Merged Document Report

Application No.: PL8504

Plat of Roy Smith Plaza Block 1, Lot 8

**Preliminary Utility Map of
 Roy Smith Plaza
 Block 1, Lot 8**

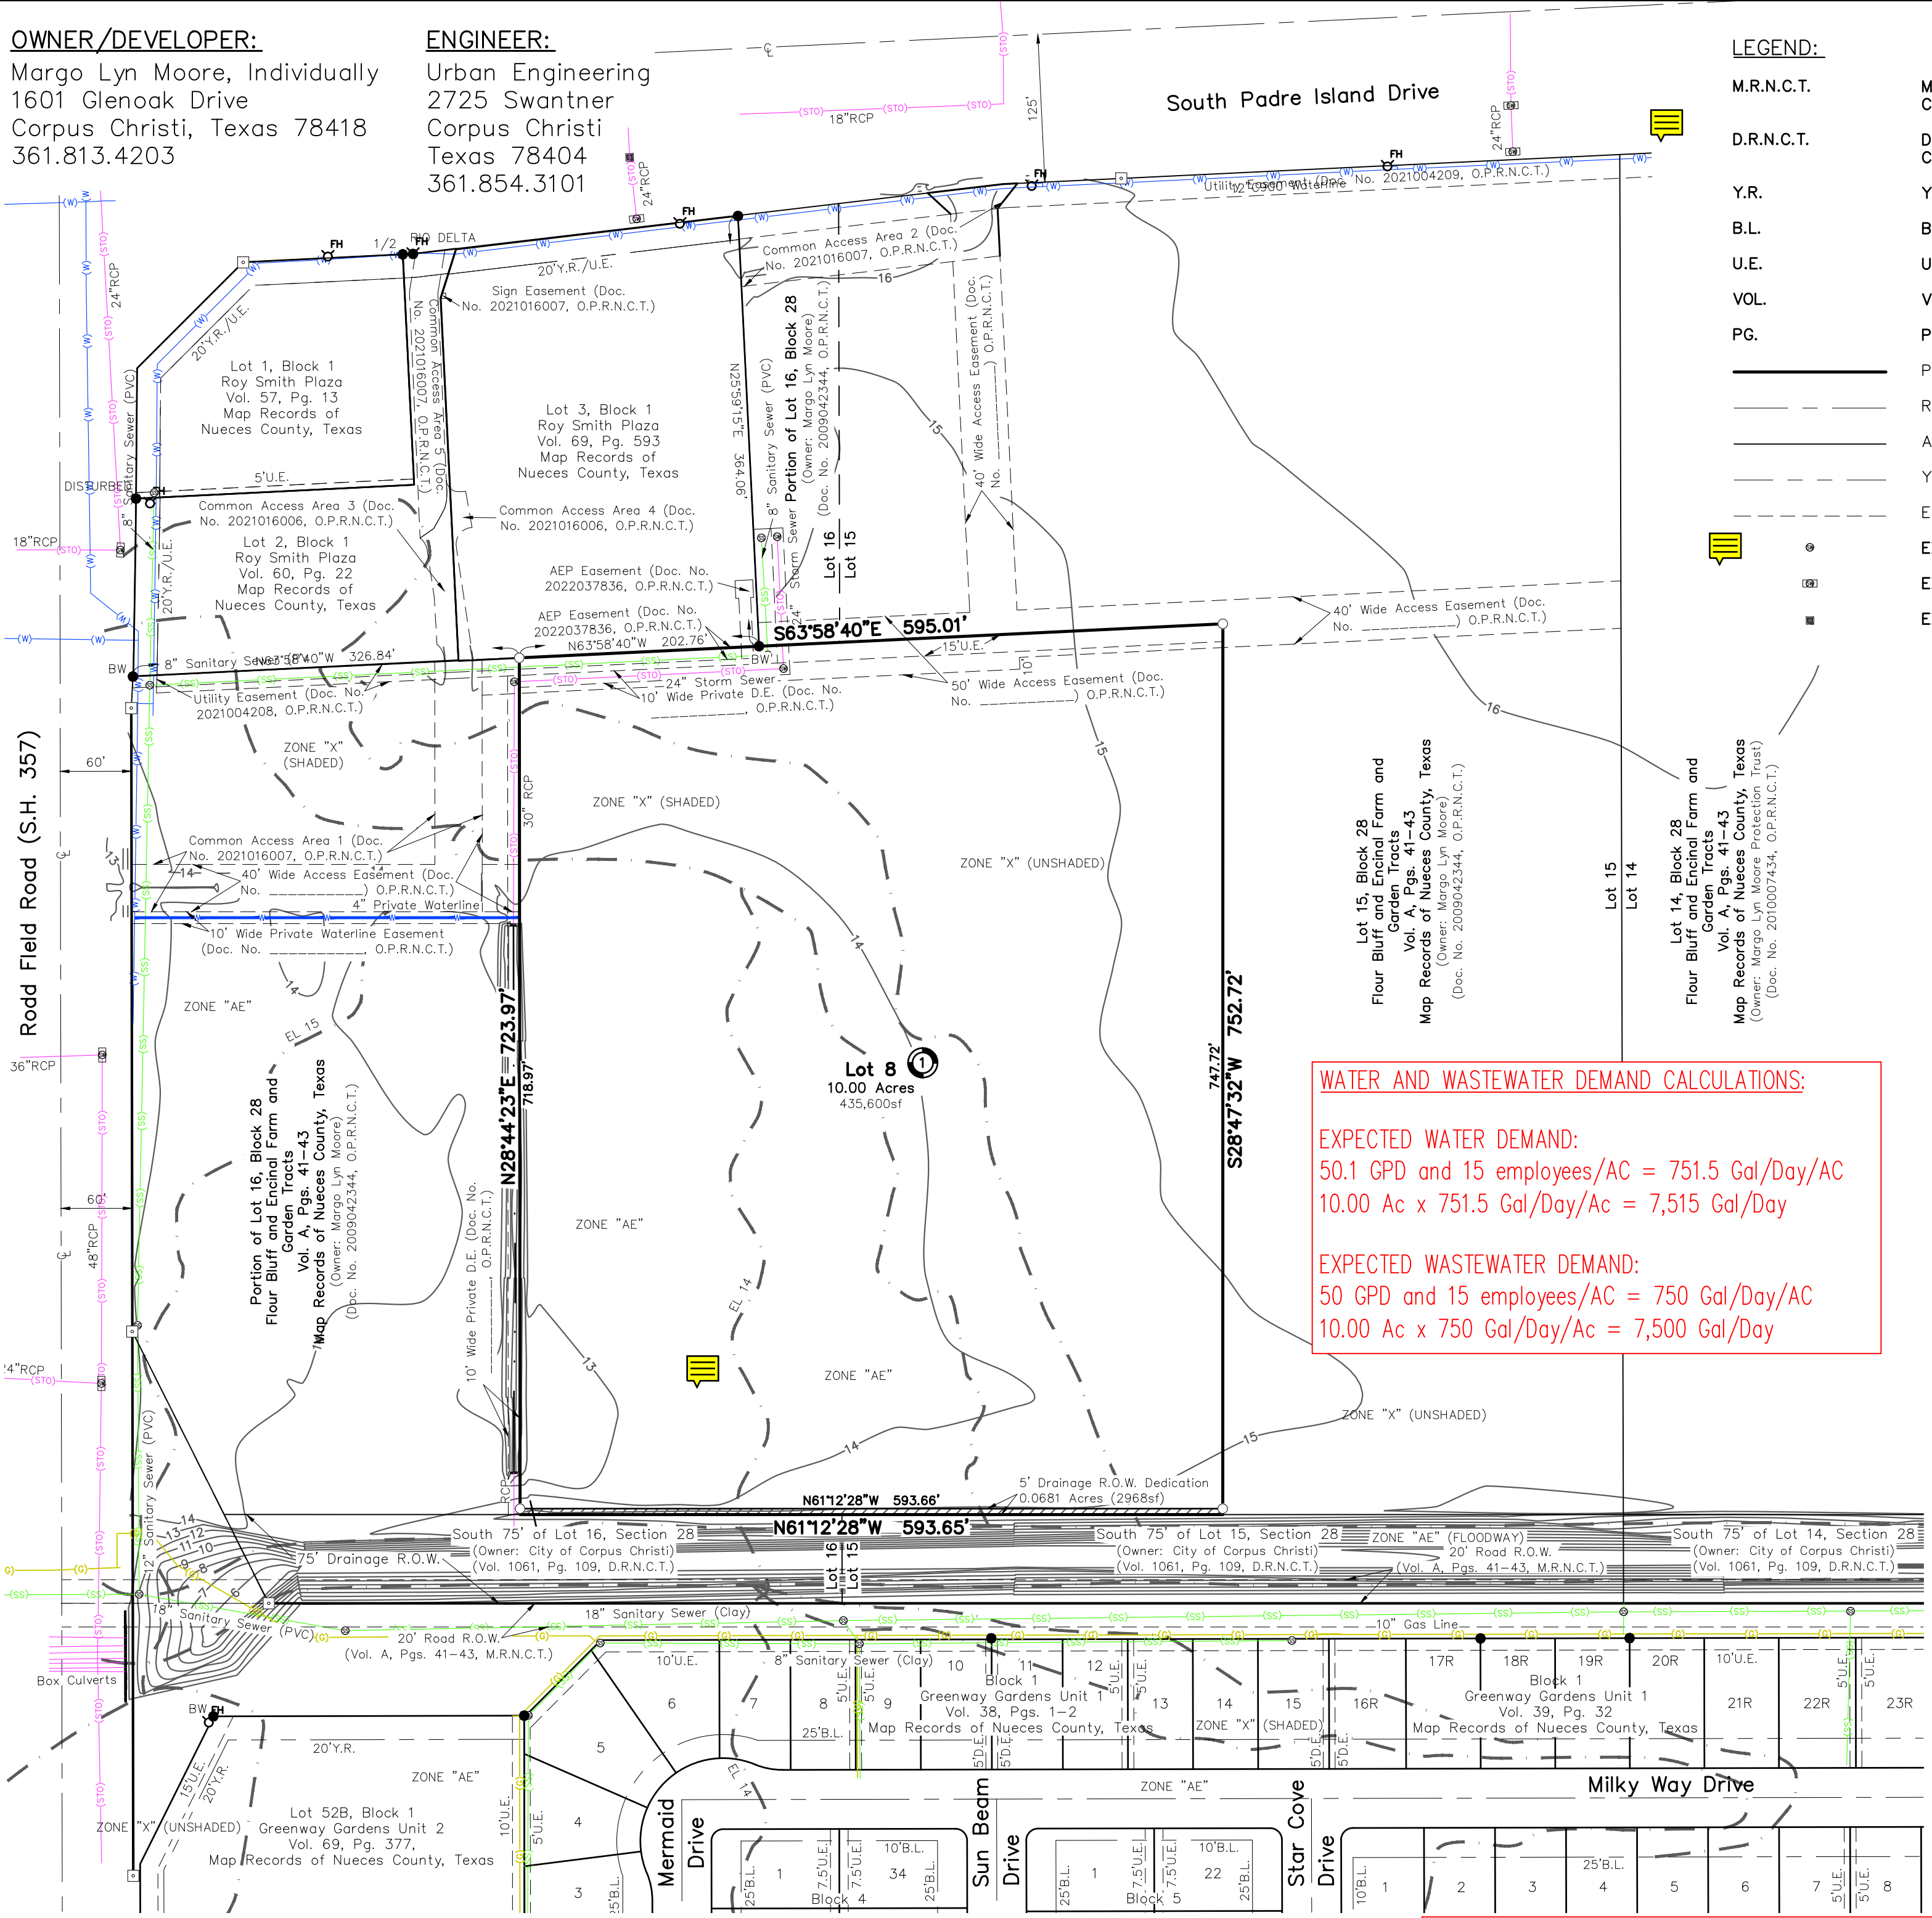
Comment ID	Page Reference	Annotation Type	Author : Department	Status	Review Comments	Applicant Response Comments
18	Utility Map	Note	Alex Harmon : DS	Open	<p>Per UDC 8.1.5., All required improvements shall be designed and installed in order to provide for a system of utilities, storm water and streets and to create continuity of improvements among adjacent properties.</p> <p>Has consideration been given to how Lot 9 will receive water and wastewater?</p>	
14	SWQMP	Note	Alex Harmon : DS	Open	<p>Show boundaries of existing wetlands on SWQMP and Plat for the following reasons:</p> <p>1. Approval from the USACE is needed prior to recordation/construction in wetland areas. Ensure the wetlands are not on site.</p> <p>2. Per City of Corpus Christi - Code of Ordinances Ch 14, Art X, Sec 14-1003, a SWQMP should identify any environmentally sensitive area that is on the site, or that would be sensitive to storm water pollution from the site.</p>

13	Utility Map	Note	Mikail Williams : WTR	Open	Water construction is required for platting (UDC 1.2.1.D & 8.2.6; Water Distribution Standards). Please show how Lot 9 will receive water service.

Preliminary Storm Water Quality Management Plan of Roy Smith Plaza

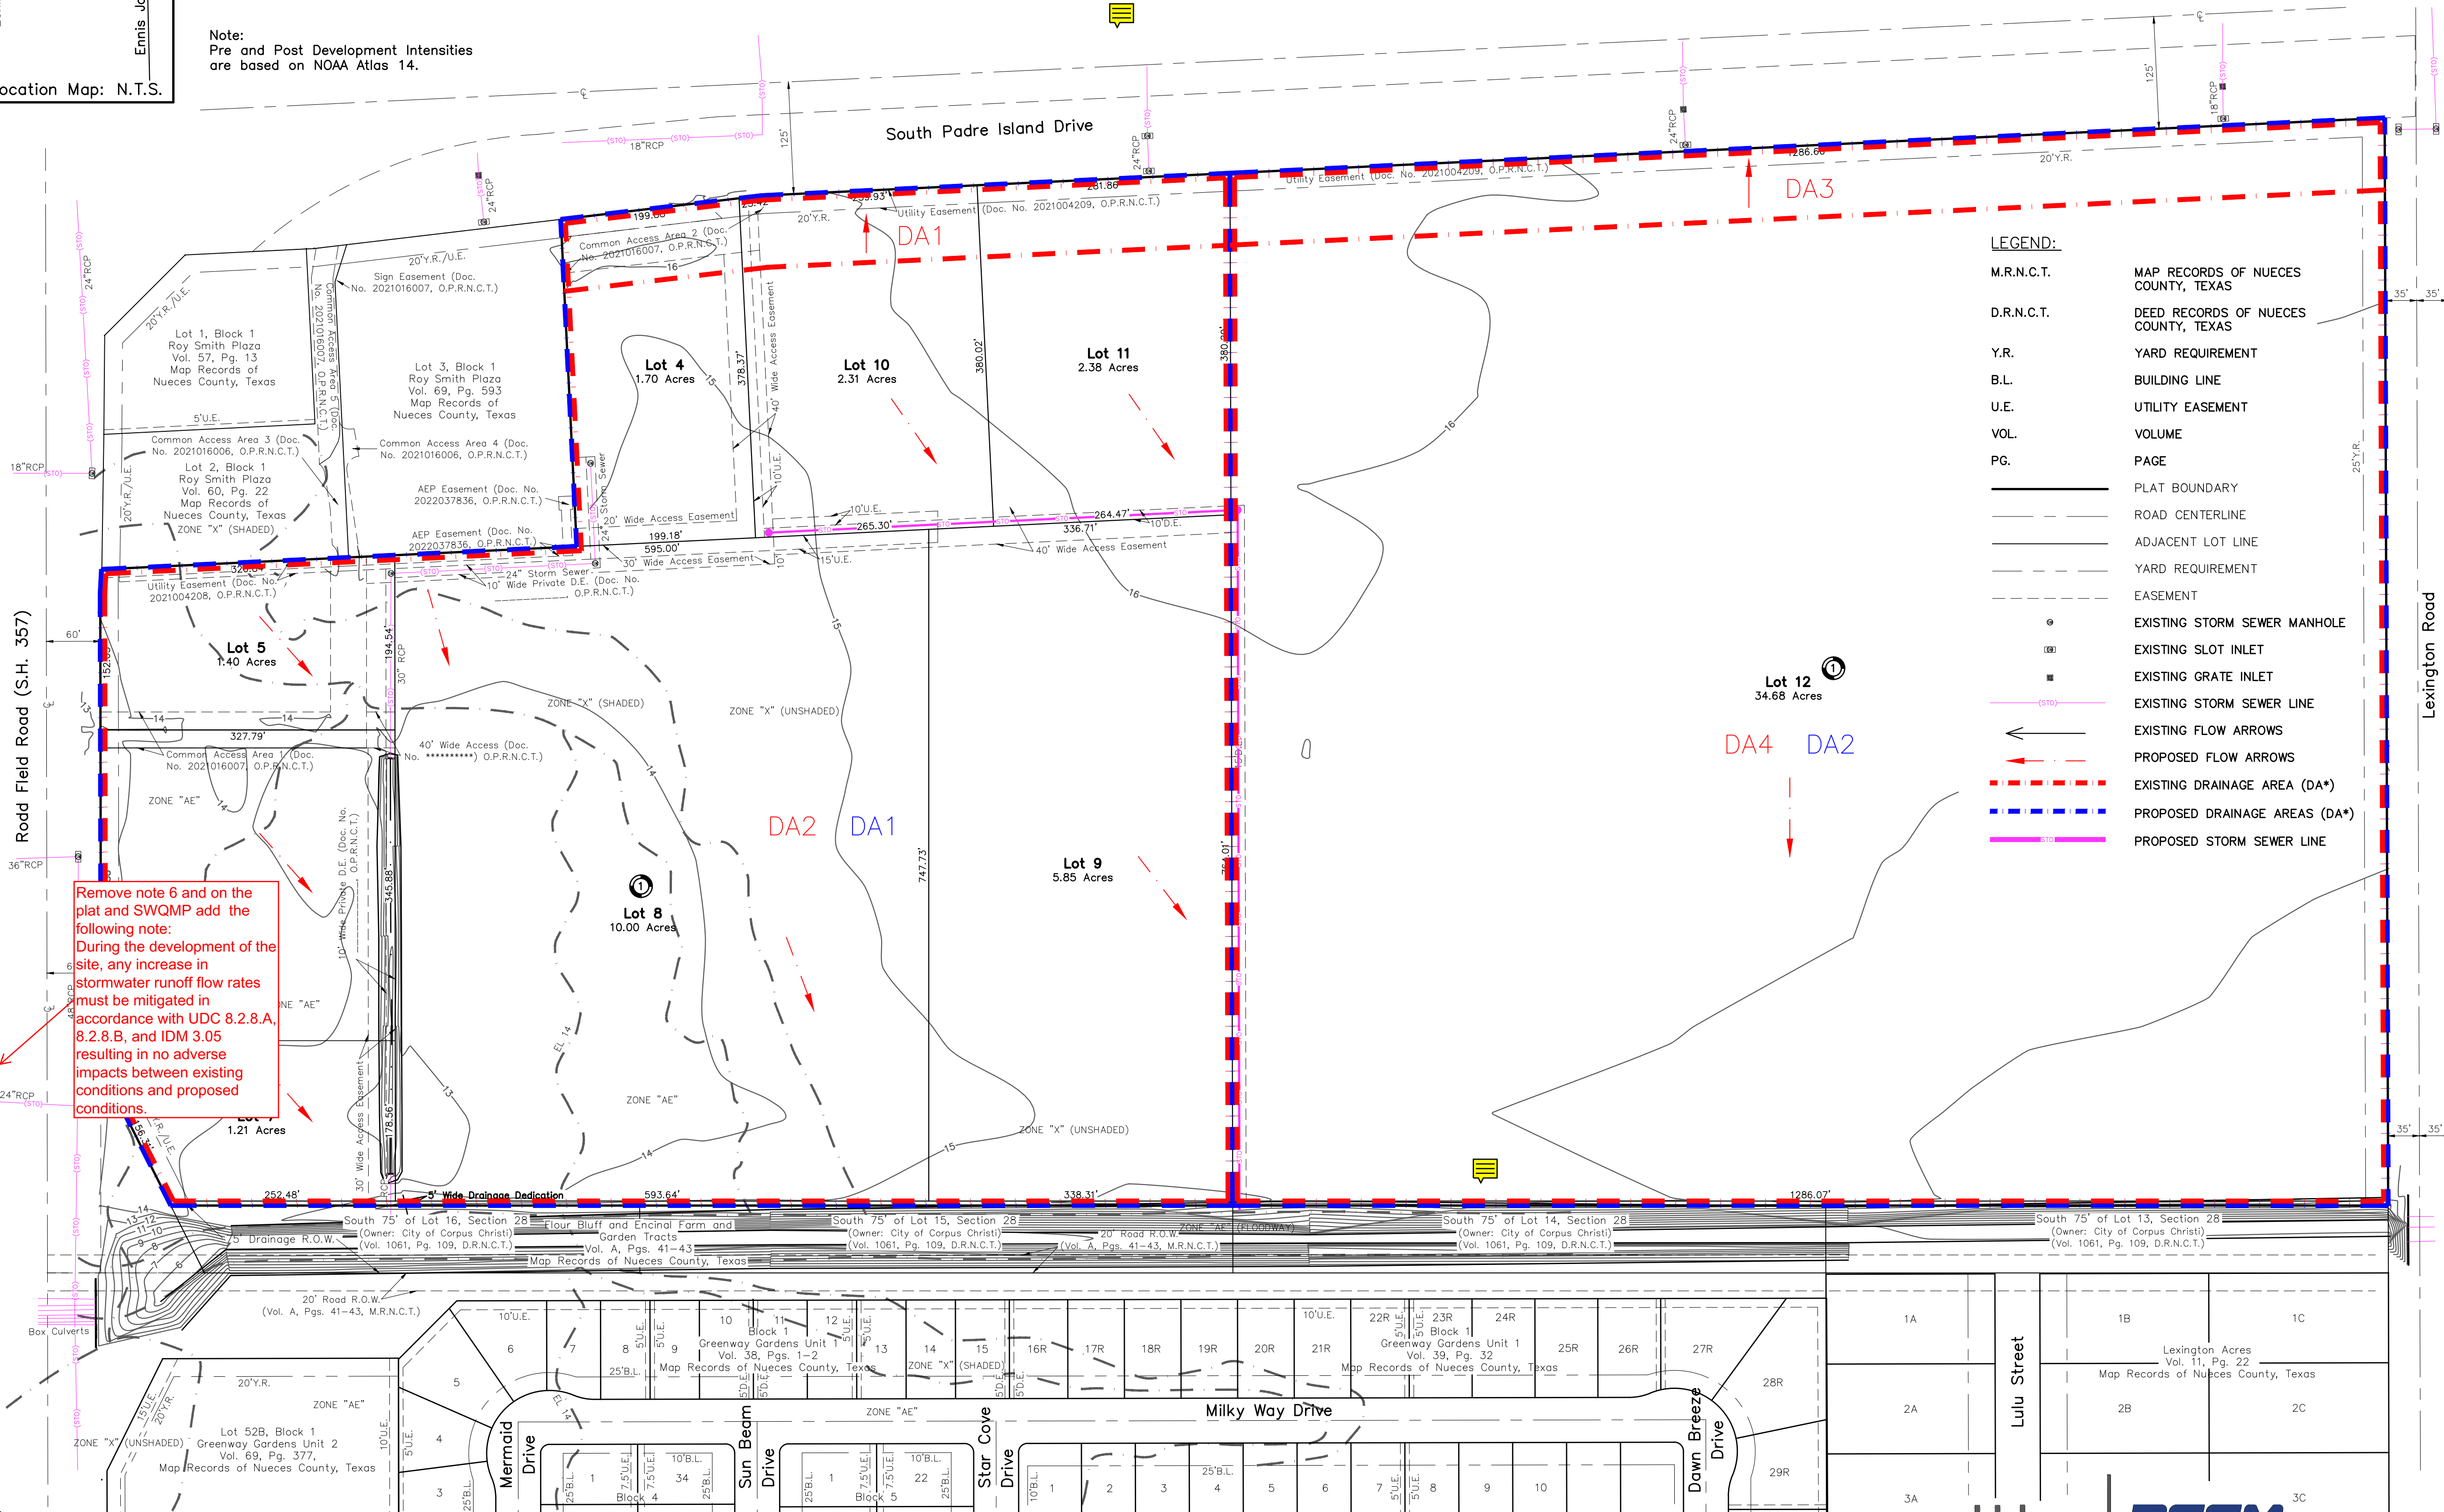
19	SWQMP	Note	Alex Harmon : DS	Open	<p>TXDOT: •No increase in storm water discharge to State right-of-way shall be accepted by TxDOT.</p> <p>•TxDOT Permits will be issued in accordance with the access management standards and all applicable state and federal laws, including rules and regulations. Access connection spacing, materials, geometrics, accessibility, and other design specifications will be considered, as well as the impact on drainage and hydraulics, utility location or relocation, and the environment that will result from the requested construction of an access connection. 43 Tex. Admin. Code § 11.52 (2020).</p> <p>•Drainage improvements shall accommodate runoff from the upstream drainage area in its anticipated maximum "build-out" or "fully developed" condition, and shall be designed to prevent overloading the capacity of the downstream drainage system</p> <p>•If the owner responsible for maintenance of the permanent stormwater or water quality control fails to maintain the control to TXDOT ROW, the owner shall correct the problem.</p>

Remove note 6 and on the plat and SWQMP add the following note:
During the development of the site, any increase in stormwater runoff flow rates must be mitigated in accordance with UDC 8.2.8.A, 8.2.8.B, and IDM 3.05 resulting in no adverse impacts between existing conditions and proposed conditions.

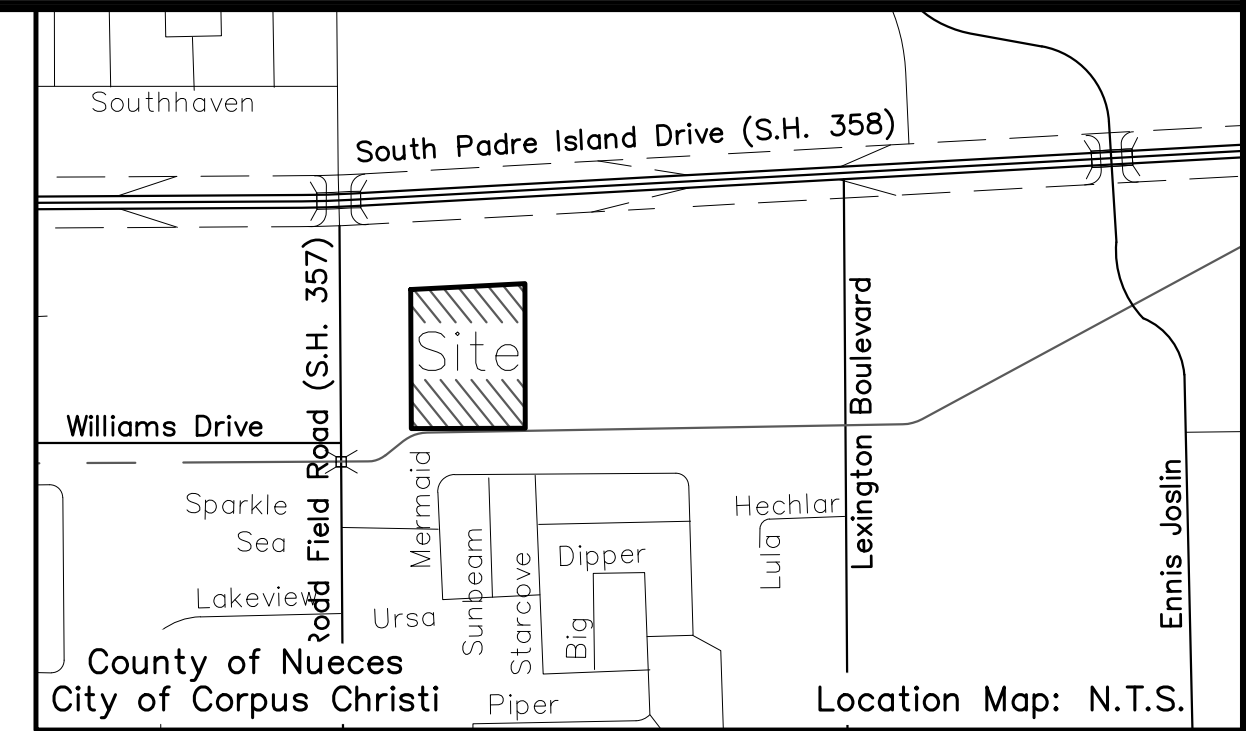
Remove Al Raymond name.
Insert Michael
Dimitrakou
